ACCESSIBILITY ASSESSMENT

December 10, 2024

ADA TITLE II ASSESSMENT

Hamlin Middle School
326 Centennial Boulevard
Springfield, Oregon 97477

Photos for Barrier ID: AX527372

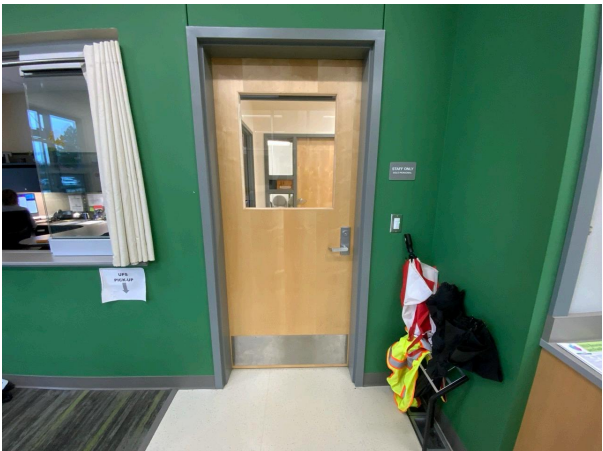
Assembly	Interior Access Route	
Type	Door	
ADA Standard	404.2.11	
Barrier Detail	The bottom of the door vision light is higher than 43" and less than 66".	
Location Description	Main Office	
Observed	Nov 22, 2024 by Jeffrey.solis@bureauveritas.com	
Site Conditions	The bottom of the vision light is at a height of 48-3/4".	
Height	48-3/4"	
Resolution	<p>Provide a door with the bottom of at least one of the glazing panels located 43" maximum above the finish floor or grade. At least one of the glazing panels shall be located for viewing through the panels, if the panel is designed for viewing. [EXCEPTION: Vision lights with the lowest part more than 66" from the finish floor or ground are not required to comply.]</p>	
Quantity	Unit Cost	Total Cost
1 EA	4,485.00	\$ 4,485
Priority	2
